LCU: Precedent and Voyager 2 System Monitoring Controls Options changes

eTPB2019 | August 14, 2020

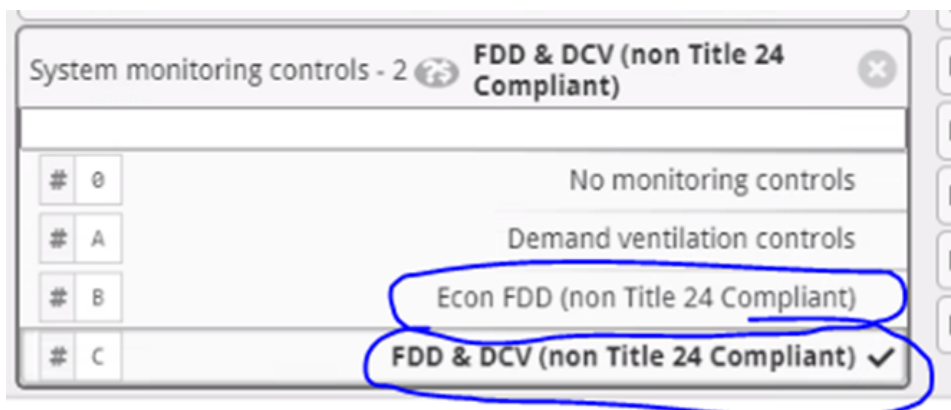
•Options for Econ FDD (non Title 24 compliant) and FDD & DCV (non Title 24 compliant) in digit 26 are discontinued in TOPSS and Job Center.

–To get the TD5 Human Interface, select Advanced Unit Controls in digit 31.

–This change is effective with replication 238.

–FD&D with the TD5 Human Interface is not T24 compliant. It may satisfy AHRAE 90.1 or IECC 2015 if the TD5 is remotely located inside the building.

–A BMS or BAYSENS924* with Bacnet will satisfy FD&D code requirements.

-Going forward, select the Advanced Unit Controls in digit 31.

-LLE in the fresh air selection must be selected when FDD is required.
